SERVICE INSTRUCTIONS

No. 0861-281
ATA Code 28-20

SUBJECT: FUEL - REPLACEMENT OF THE FUEL BOOST PUMP

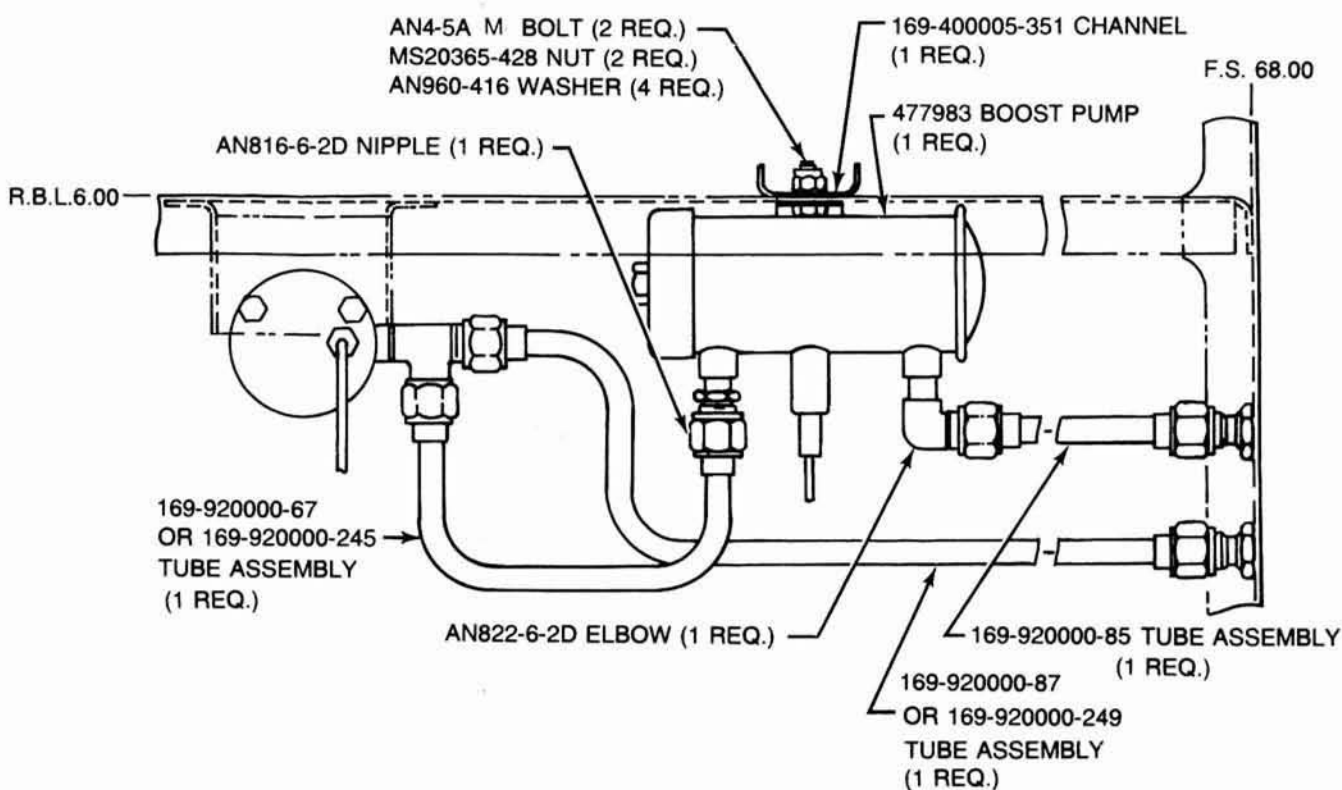
The existing fuel boost pump is removed and the Kit No. 23-9020-1 S fuel boost pump assembly is installed in the airplane serials indicated.

The existing fuel boost pump is removed and the Kit No. 23-9020-3 S fuel boost pump assembly is installed in the airplane serials indicated.

2. Remove the co-pilot's seat.
3. Remove the co-pilot's rudder pedal cover assembly.
4. Remove the boost pump access door.
5. Remove the fuel boost pump.
6. Remove the tube assembly, boost pump to firewall.
7. Remove the tube assembly, firewall to strainer tee.
8. Remove the tube assembly, strainer tee to boost pump.
9. Install AN816-6-2D nipple to the "In" port of the new boost pump.
10. Install AN822-6-2D elbow to the "Out" port of the new boost pump.
11. Install the P/N 477983 boost pump and 169-400005-351 channel with AN4-5A/M/ bolt, AN960-416 washer, and MS20365-428 nut through the existing holes in the keel at fuselage station 78.40 (10.4 inches aft of the firewall).

Trim the diagonal channel between the inboard and outboard keel as necessary to provide clearance between the channel and the new boost pump.

It may be necessary to make minor adjustments to the tube assemblies and/or shim the firewall fittings in order to ensure proper alignment of the installation. Use care when hand-bending the tube assemblies so as not to crimp or damage them.
